# UNITED STATES PATENT AND TRADEMARK OFFICE

10/561,401

<b>Office Action Summary</b>	<b>Application No.</b> 10/561,401	<b>Applicant(s)</b> NAATTI ET AL.	
	<b>Examiner</b> Juan J. Campos	<b>Art Unit</b> 4136

## **DETAILED ACTION**

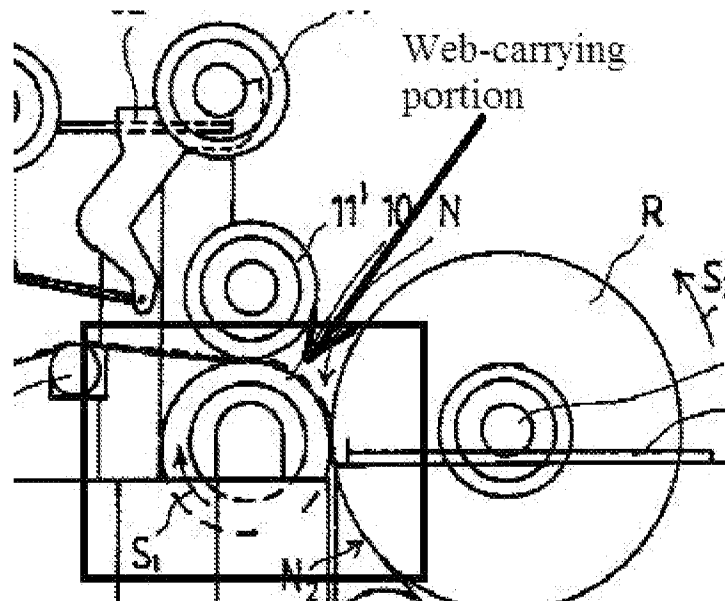
Additionally, Kinnunen et al. discloses that the rests and revolves in its reeling positions, e.g., on two carrier rails 12 (see column 6, lines 16-18). The two carrier rails are also considered a device for keeping the new reel spool (or new reeling core) in a primary reeling station (the area next to reeling cylinder 10) where the paper web is guided around the new reel spool through a reeling nip, N. Kinnunen et al. discloses a loop of belt F (or support member) where there is a web-carrying portion traveling in a travel direction (see figure below) with portion forming the reeling nip of secondary reeling (see  $N_2$ ) and with the carrier rails (or transfer device) being arranged to transfer the reel R in the secondary reeling so secondary reeling moves in the travel direction of web-carrying portion. Kinnunen et al. also shows a guide roll 21 (or first guide roll) inside the loop of the belt F having an axis being located in the travel direction of the support member (see figure 1) in the beginning of the web- carrying portion (the area near the reeling cylinder 10) forming the reeling nip of secondary reeling ( $N_2$  or  $N_3$ ), see figures 1-5. In addition, Kinnunen et al. shows that the first guide roll being arranged movable in the direction of the edge (or periphery) of the reeling spool in the primary reeling station (the area next to reeling cylinder 10) so that the distance of the reeling nip between the reeling spool and the loop of the belt F from the first guide roll changes (see right side of figures 1-5). Also, as can be seen in figures 1-3, the new spool 11' is brought to the change station (discussed earlier) against the loop of the belt with substantial vertical linear movement. The method of operating the apparatus is well

known and no new, non-obvious or improvement claims are described by the method claim since all elements of the Kinnunen et al. device are disclosed in detail above.

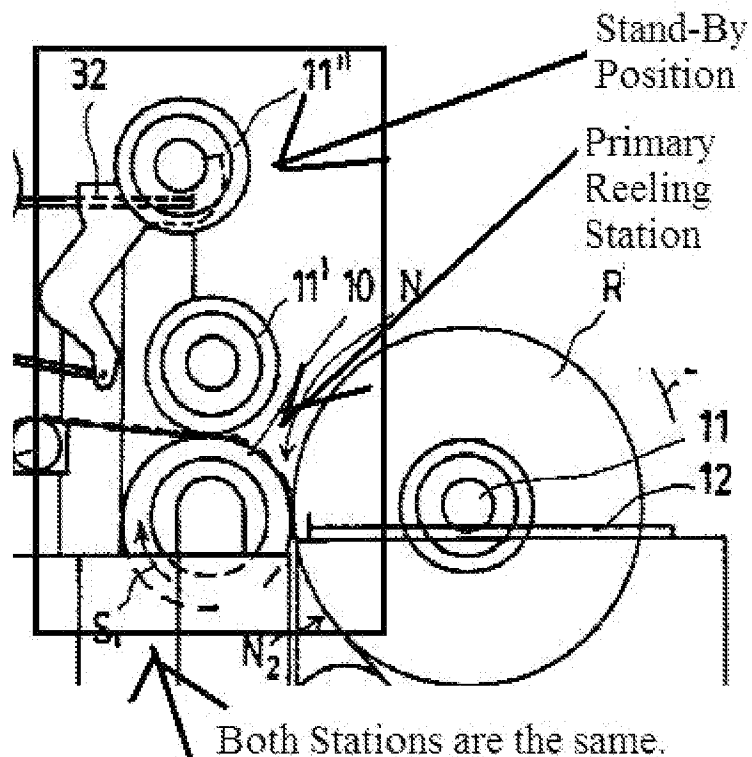
**Regarding claims 30-31,** Kinnunen et al. discloses a stand-by position (or change station), assumed to be the location of spool 11'', and primary reeling station (the area next to reeling cylinder 10). From reviewing figures 1-5, and figure provided below, the stand-by position and primary reeling station are considered the same and implemented by the reeling

cylinder (10) which is arranged to keep the new reel spool (using the carrier rails 12) in both the stand-by position and primary reeling station.
